Board of Adjustment

Staff Report

CASE NUMBER: BA17-016 (PLN2016-00937)
LOCATION/ADDRESS: 1300 S Country Club Drive
COUNCIL DISTRICT: District 3
STAFF PLANNER: Lisa Davis, Planner II
OWNER: 1250 Country Club Drive LP-Jim Rudnick
APPLICANT: Stewart & Reindersma Architecture, PLLC- Sake Reindersma

REQUEST: *Requesting a Substantial Conformance Improvement Permit (SCIP) for the redevelopment of an existing retail center in the LC zoning district.*

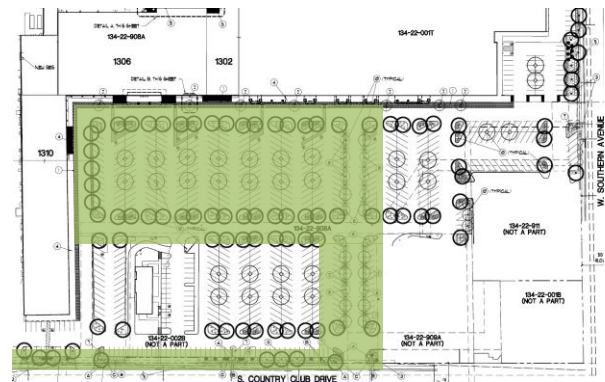
All of the landscape to be replaced within the parking lot is proposed to be installed as part of phase 2. Staff recommends that the parking area, the main entrance from Country Club and the landscape along Country Club be installed with phase 1. (pictured to the right) This is consistent with requirements of similar projects. The required landscape islands are not existing on the site and staff is not asking that they add the additional landscape islands. Diamond landscape areas are proposed throughout the parking lot. This will help to mitigate the sea of asphalt currently on the site and bring the site into more significant conformance with code.

3. **As per MZO Section 11-30-9 screening of roof mounted mechanical equipment shall be required.**
4. **Screening shall be provided to meet the requirements of Mesa Zoning Ordinance (MZO), Section 11-30-9.H, for parking spaces adjacent to Country Club Drive and Southern Avenue. Screening of the parking and circulation areas adjacent to Country Club Drive shall be addressed at phase 1.**
